**CHAPTER 2 REVISIONS TO THE DRAFT
EIR TEXT**

This chapter presents minor corrections and revisions made to the Draft EIR (DEIR) initiated by the public, staff, and/or consultants based on their on-going review. New text is indicated in underline and text to be deleted is reflected by a ~~strike-through~~. Text changes are presented in the page order in which they appear in the DEIR.

FIGURE 3-14
NQSP Proposed Zoning

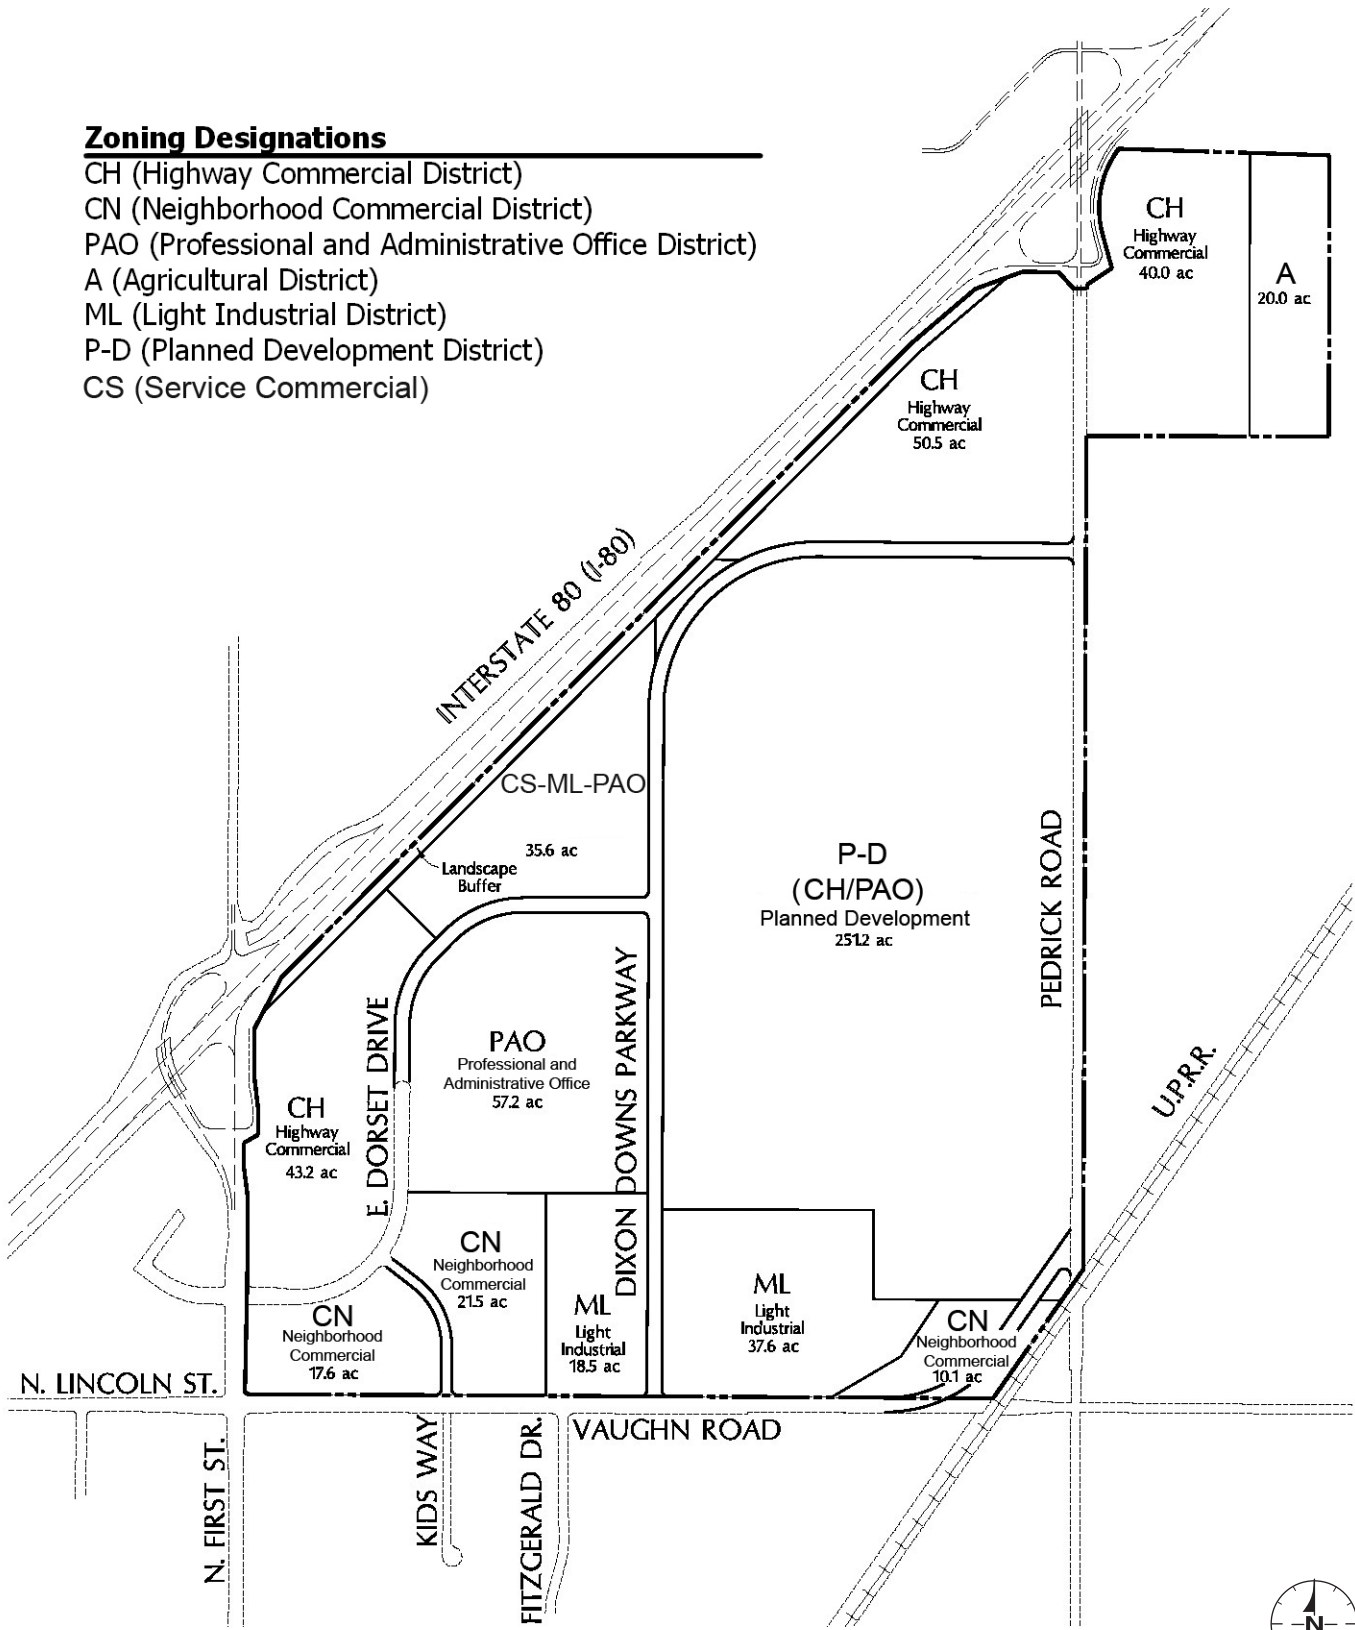
Figure 3-14 on page 3-53 is revised and included on the following page.

FIGURE 4.7-1
Existing Zoning Designations

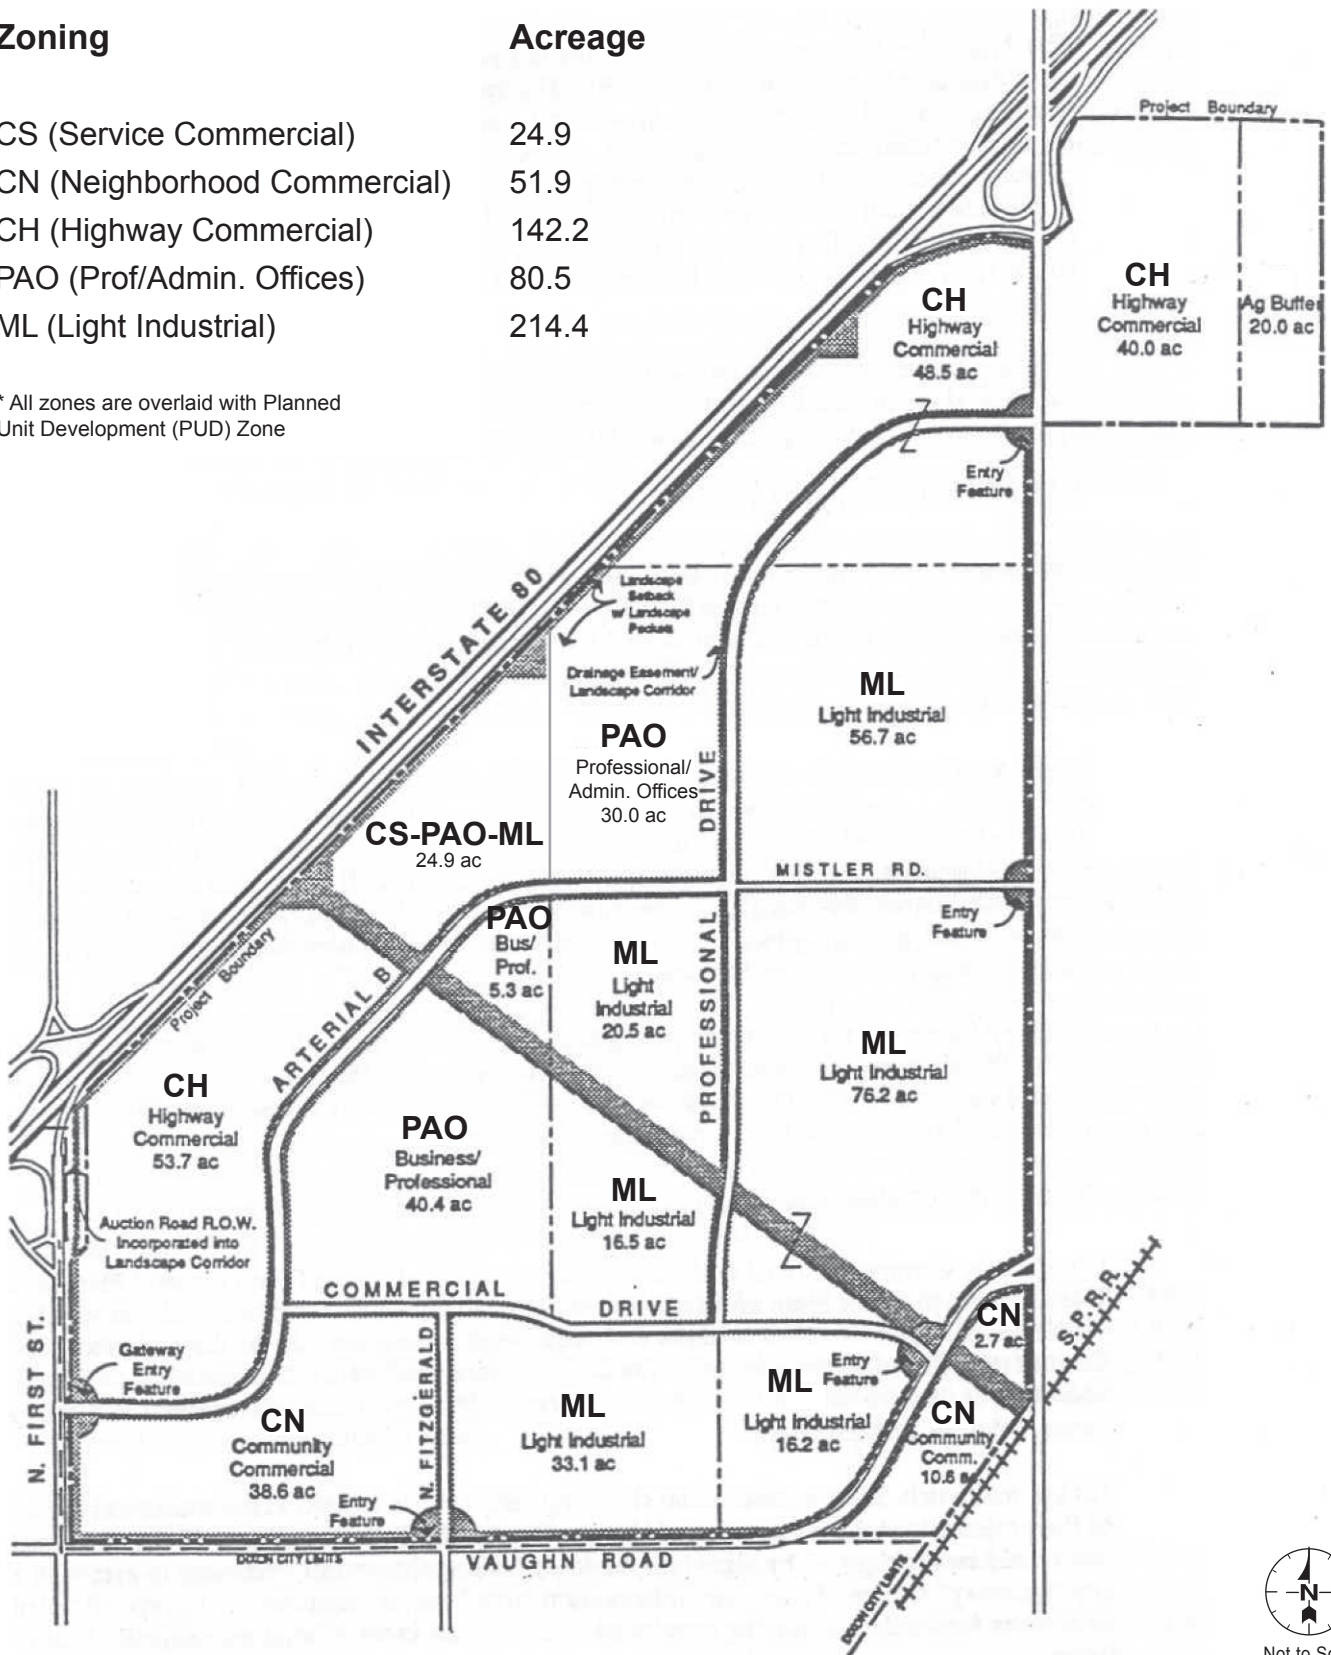
Figure 4.7-1 on page 4.7-3 is revised and included on the following page.
